# Access Compliance Report

## Public Rights-of-Way

Intersection ID: 10027413	Main Street: GOLF_LINKS_DR_N	Cross Street: N/A	Location: SE
ADA ID: F644449335CE	Ramp Type: Perp	Initial Pass/Fail: Fail	Overall Compliance: No
Severity Score: 1.25			
Codes/Mitigation Info/Possible Solution		Field Measurements/Component Compliance

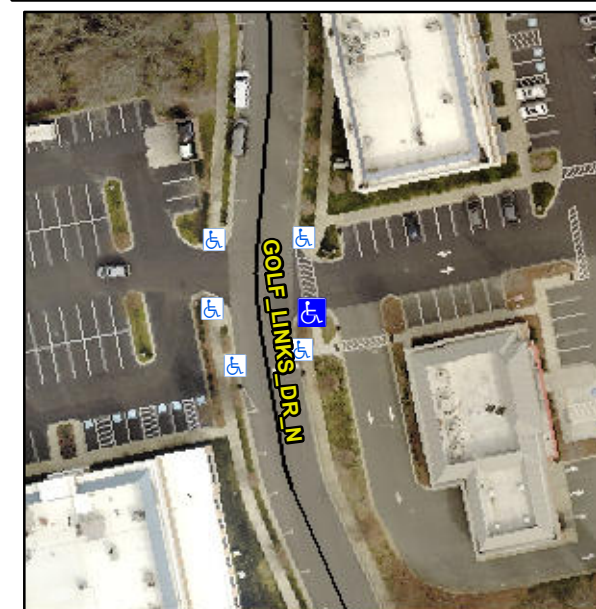
**Not Found, R304.5.3**

Compliance	Description	Data	Compliance	Description	Data
N/A	Ramp Length (in)	60.0	Yes	Ramp Slope (%)	6.0
Yes	Ramp Width (in)	50.0	No	Ramp XSlope (%)	2.2
N/A	Flare Type LT	N/A	N/A	Flare Type RT	N/A
N/A	Flare Slope LT (%)	N/A	N/A	Flare Slope RT (%)	N/A
N/A	Flare Traversable LT?	N/A	N/A	Flare Traversable RT?	N/A
N/A	Landing Length (in)	N/A	N/A	DWS Provided?	N/A
N/A	Landing Width (in)	N/A	N/A	DWS Contrast?	N/A
N/A	Landing Slope (%)	N/A	N/A	DWS Length (in)	N/A
N/A	Landing X Slope (%)	N/A	N/A	DWS Full Width?	N/A
N/A	Landing Curb? (Y/N)	N/A	N/A	DWS Offset (in)	N/A
N/A	Shared Landing?	N/A			
N/A	Gutter Ponding?	N/A	N/A	Gutter Slope (%)	N/A
N/A	Gutter Lip Ht (in)	N/A	N/A	Gutter X Slope (%)	N/A
N/A	Painted X Walk1?	Yes	N/A	Painted X Walk2?	N/A
	X Walk 1 Direction	To N		X Walk 2 Direction	N/A
N/A	X Walk 1 Width (in)	88.0	N/A	X Walk 2 Width (in)	N/A
	X Walk 1 Slope (%)	0.7		X Walk 2 Slope (%)	N/A
	X Walk 1 X Slope (%)	2.6		X Walk 2 X Slope (%)	N/A

**Remove & Replace Entire Ramp.**
